Sec. 5.15 MISCELLANEOUS OLD TOWN BLUFFTON HISTORIC DISTRICT

Purpose: The following are miscellaneous amendments related to Old Town Bluffton Historic District.

Sec. 5.15.6.G. OTBHD, Architectural Standards, Building Walls

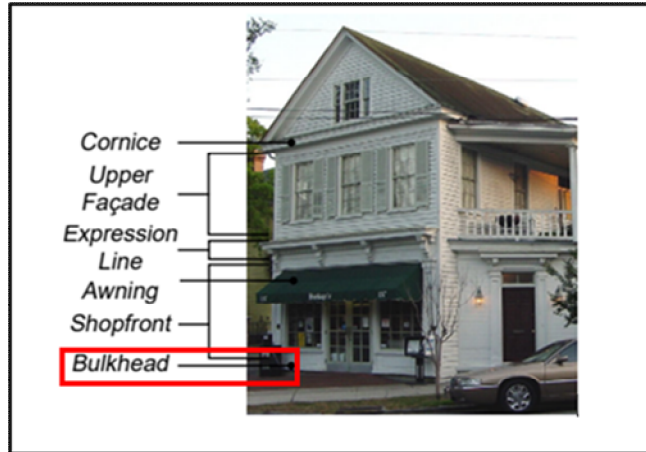
Purpose: Remove the word “bulkhead” from the following photograph as it is not a term used in the UDO.
